HOUSING INFRASTRUCTURE FUND: REVIEW OF  
"3 WATERS" INFRASTRUCTURE DETAILED  
BUSINESS CASE - LADIES MILE

PREPARED FOR **MINISTRY OF BUSINESS, INNOVATION AND EMPLOYMENT**

9 July 2018

Figure 6-2: reservoir elevation of 420m to match the existing quail rise reservoir (marked in red)

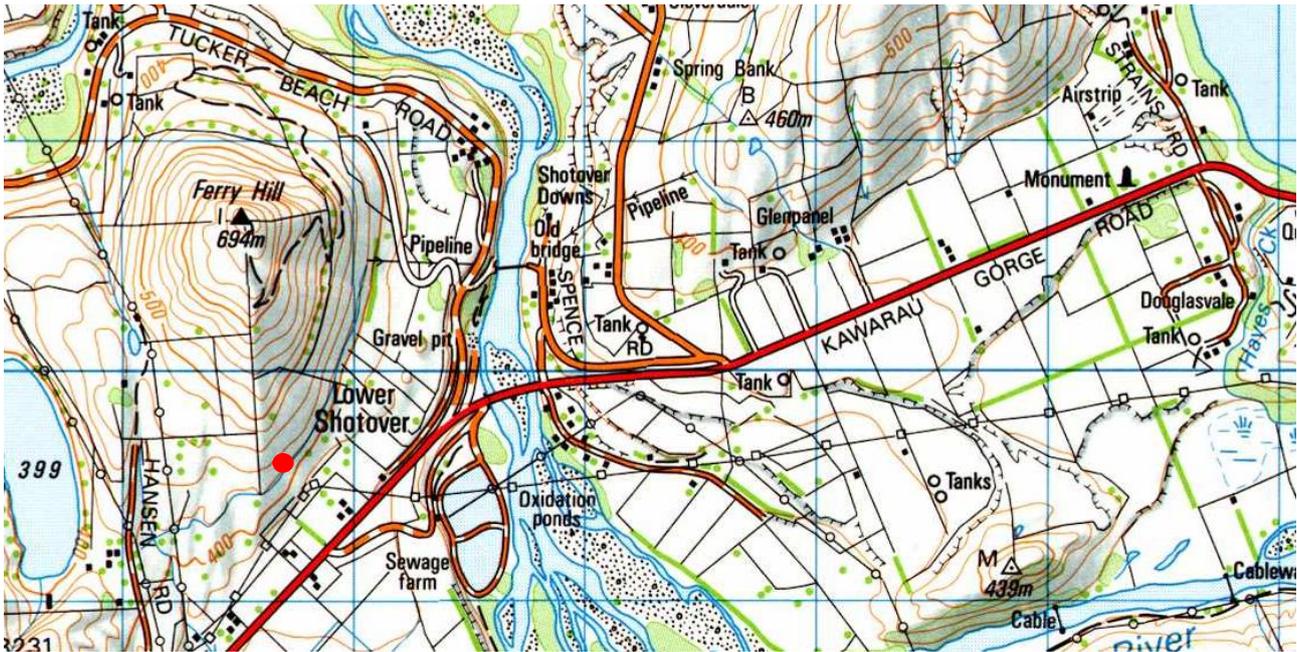
WSP Opus identify the level of the reservoir to be RL 423 to match the existing quail rise reservoir. No specific location for the reservoir has been identified so far. As can be seen in the figure below this **reservoir elevation appears to be an appropriate selection;**

Figure 6-3: Location of proposed new wastewater pump stations (circled in red)

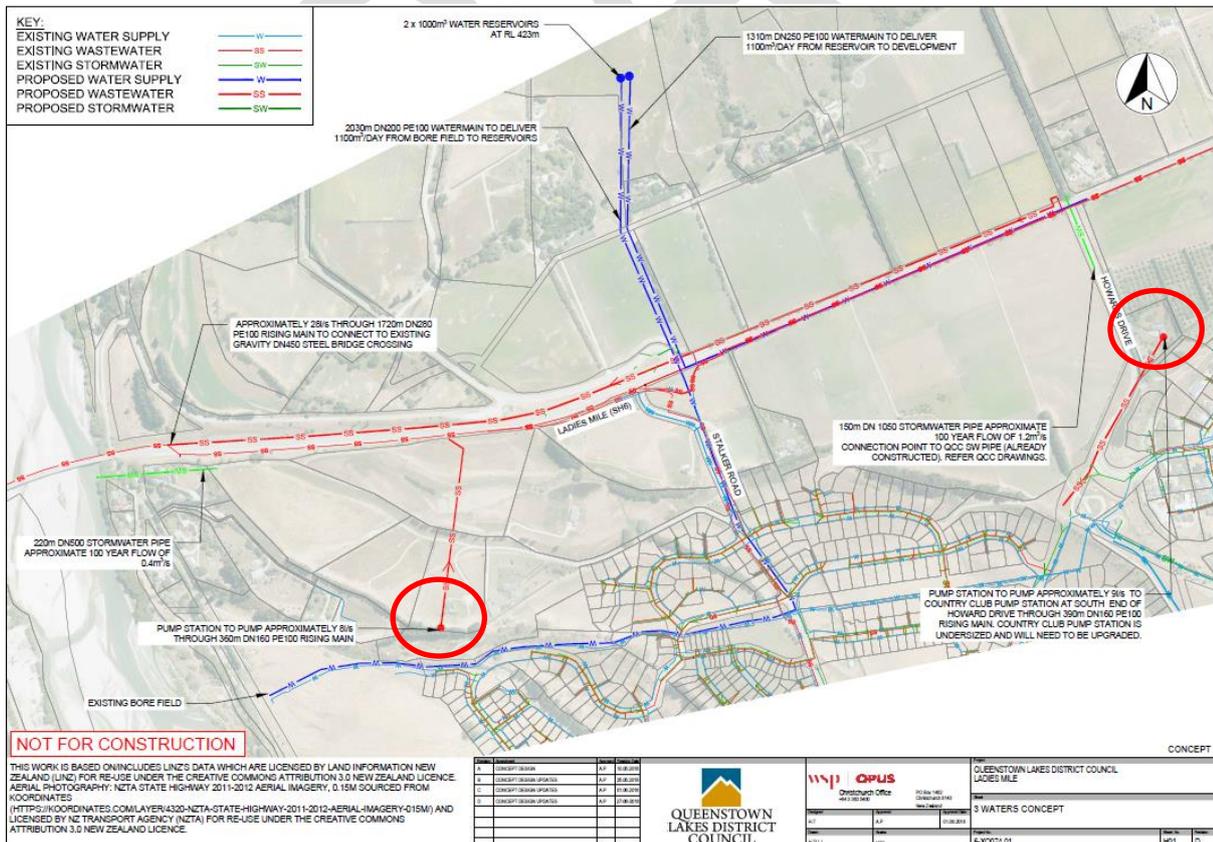
One or more additional (larger) pump stations will also be required for the Glenpanel development north of Ladies Mile. This is to be provided separately by the land developer.

No specific details of the pump stations has been provided. Issues such as emergency storage, standby generation, necessity for odour control and power reticulation remain to be addressed. These issues are common technology and do not present significant technical problems.

Figure 7-1: Catchment areas, nomenclature and stormwater flow

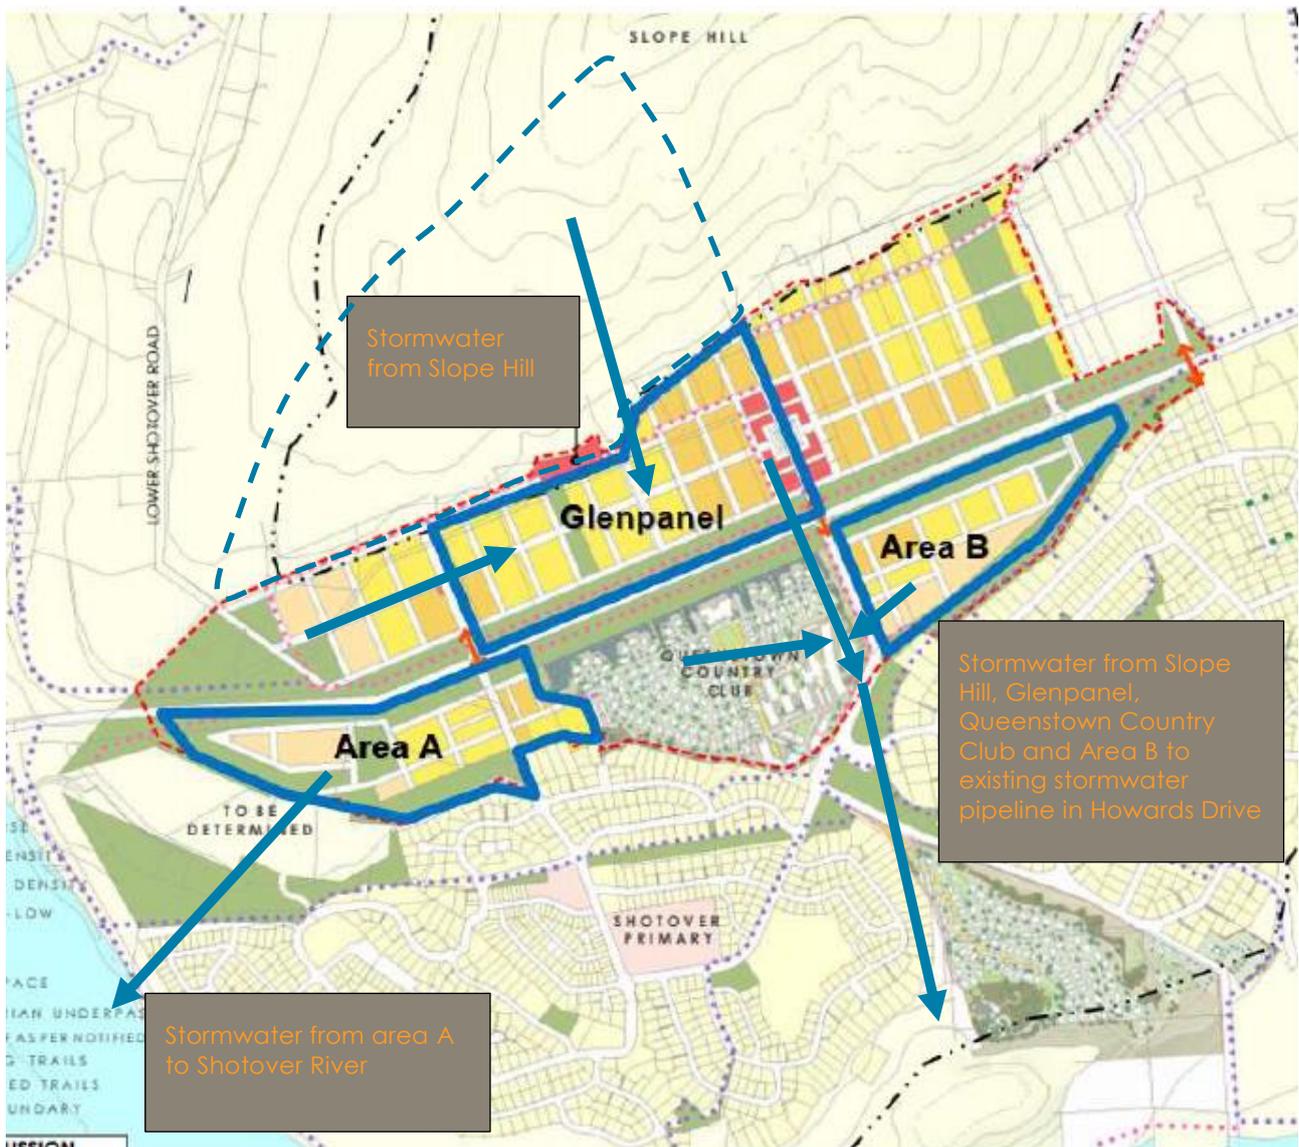
- the Glenpanel area of the development north of SH 6 will discharge into the existing stormwater pipeline laid in Howards Drive and then towards the Kawarau River
- Area B will also discharge to the same pipeline
- Area A will discharge to a new pipe west to the Shotover River
- Flows from the Slope Hill catchment above the Glenpanel area are proposed to be diverted around the Glenpanel development to separate discharge points – this is discussed further below.

The initial draft WSP Opus report received by Stantec included an assumption that runoff from Slope Hill was cut off before reaching the Glenpanel area and diverted west to Shotover River by an assumed channel, and that the remaining runoff from Glenpanel could then be passed by surplus capacity in the new stormwater from Queenstown Country Club. When Stantec pointed out that this cut off likely did not exist, the report was amended to report that runoff from Slope Hill instead discharges east of Glenpanel following "natural secondary flow path", and then to Lake Hayes.

The latest WSP Opus report states that "The overland flow paths from the contours show flow from the hill passing through the site and through to the adjoining development area towards Lake Hayes. It is best practice to continue to allow the flow paths to follow these pre-existing paths. In the future QLDC will need to construct a new SW pipe from this other development area through to Lake Hayes, and the developers should design swales, paths or roads to allow these secondary flow paths." Section 7.3 includes comment on Stantec assessment of stormwater drainage patterns.
